Owner Occupied and Scattered Site Rehabilitation Programs

Addendum #1

April 10, 2015

Project # 5004 Property Address: 166 Woodward Avenue, Norwalk, CT

Figure 1 - Photograph Submitted to MCA by Contractor

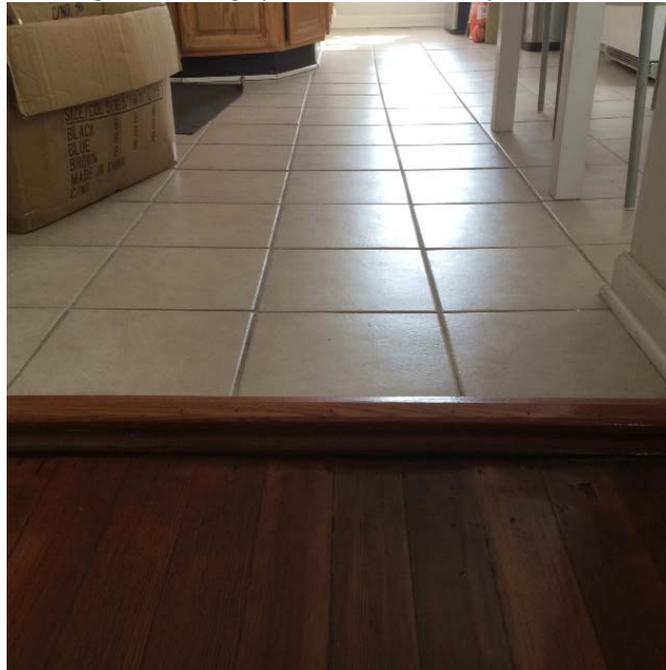
I attended today's bid walk at 166 Woodward Ave. in Norwalk today. I walked the job with our house lifting contractor and we noticed areas of concern in the home in regards to the framing and support structure. He informed me these areas where there was evident structural "sagging" would affect the integrity of the flooring tile, sheetrock walls, and interior finishes during the lifting process. I have attached pictures of the kitchen showing the areas of concern.

Interior finish damages caused during home elevation will be corrected by contractor as part of the base bid.

Drawing Sheet A-1.1

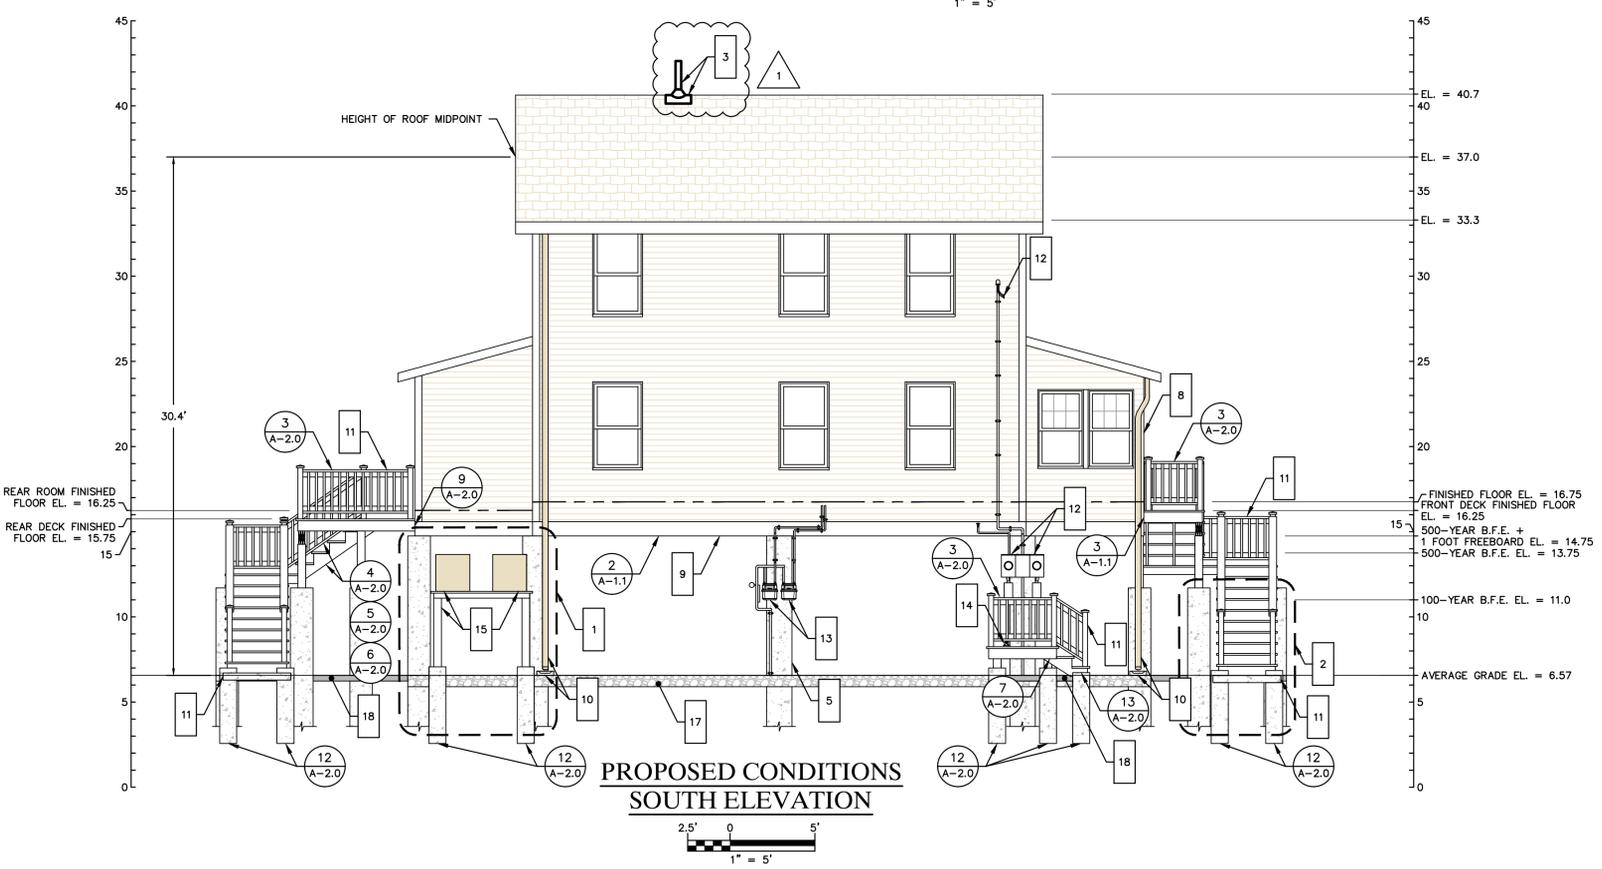
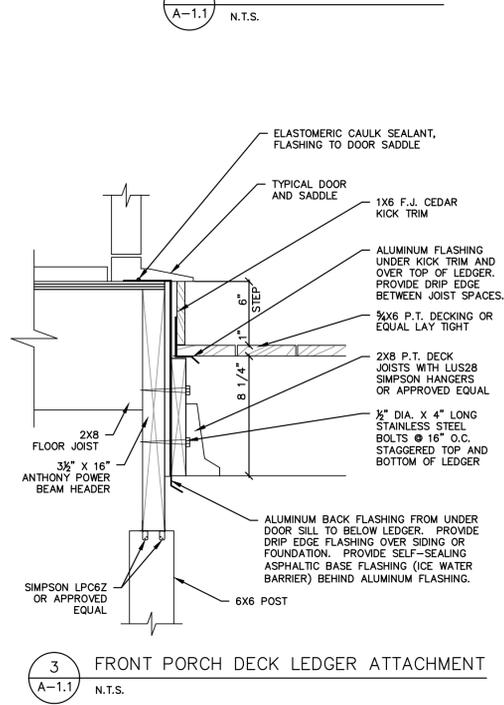
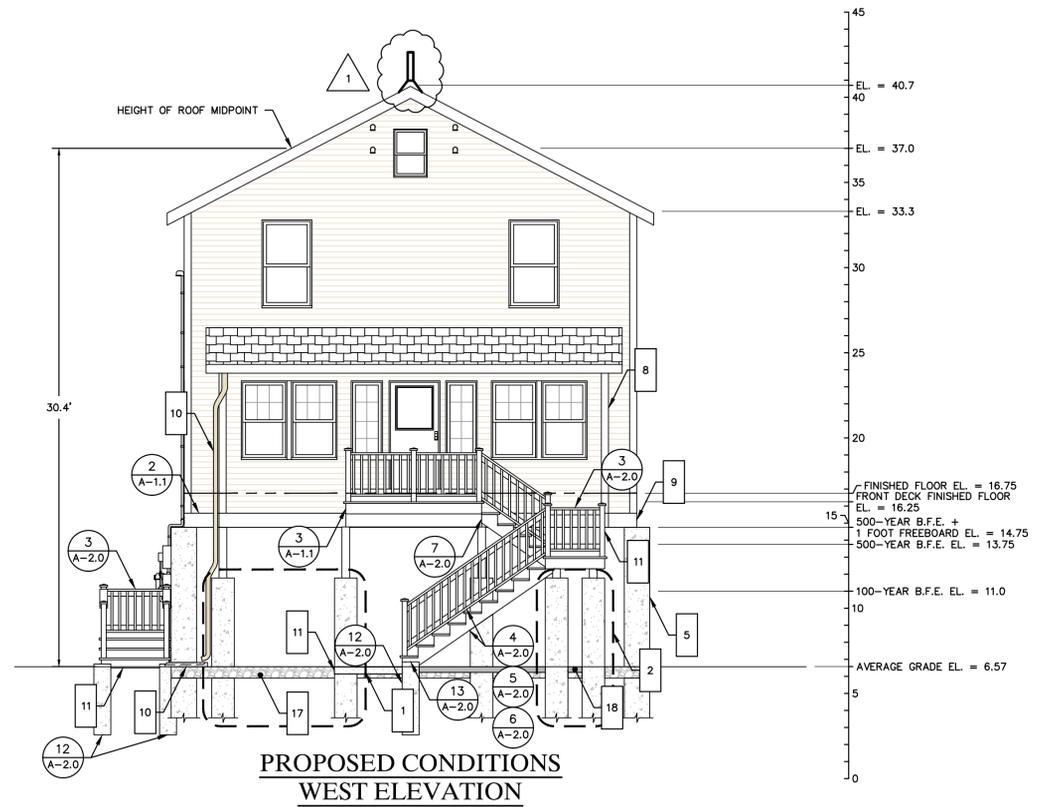
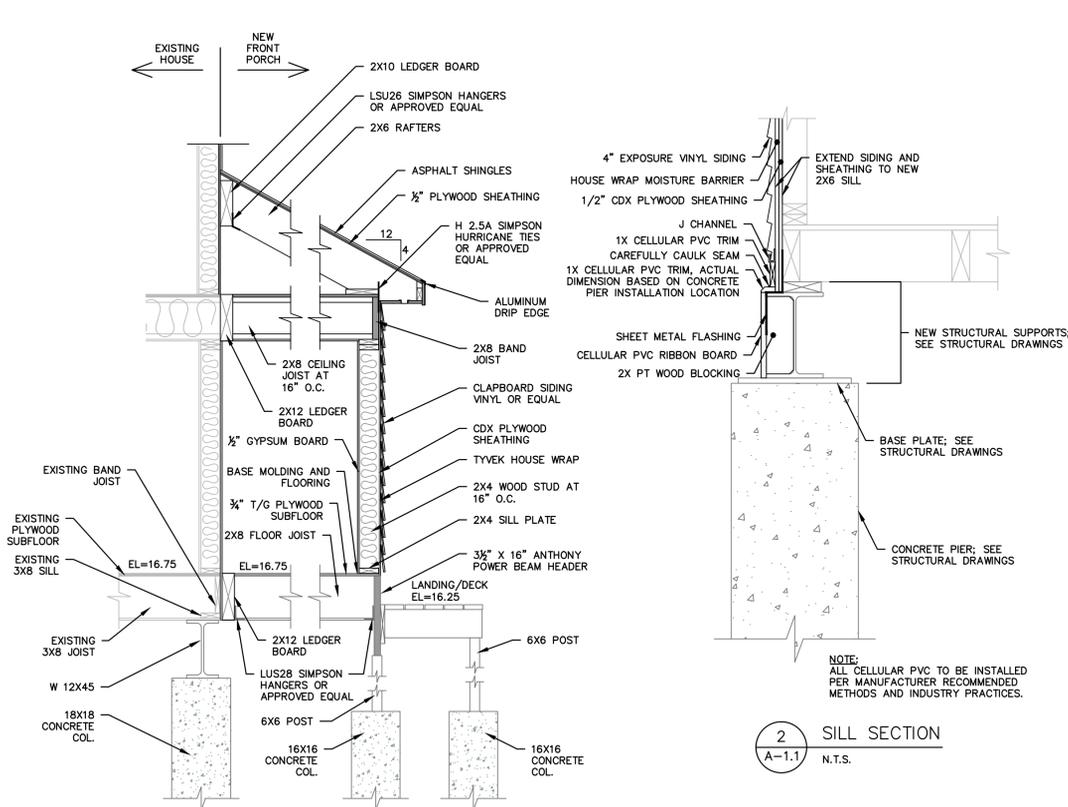
1. Drawing sheet A1.1 and modify work note 3. Revised drawing is included as attachment 2
2. Drawing sheet C1.3 add work note 11. Revised drawing is included as attachment 3
3. Drawing Sheet SK-1 is incorporated into the bid documents for bid item Add/Alternate 1 of a concrete slab beneath the foot print of the home. SK-1 is included as attachment 4 to this addendum
4. Drawing Sheet S-2, area of two (2) stair cases to basement level to be infilled with 2x8 joists at 16" on center at first floor stair opening. Provide 3/4" tongue and groove plywood floor sheathing.

- 1 HOUSE FOUNDATION; SEE STRUCTURAL DRAWINGS
- 2 STAIR FOUNDATION; SEE STRUCTURAL DRAWINGS
- FURNISH AND INSTALL ALL MATERIALS TO PATCH ROOF WHERE CHIMNEY WAS REMOVED, MATCH EXISTING CONSTRUCTION. FURNISH AND INSTALL FLASHING FOR NEW HOT WATER HEATER FLUE. USE GALVANIZED STEEL ROOF BOOT SEALED WITH HIGH-TEMPERATURE SILICONE SEALANT. SEE SHEET C-1.3
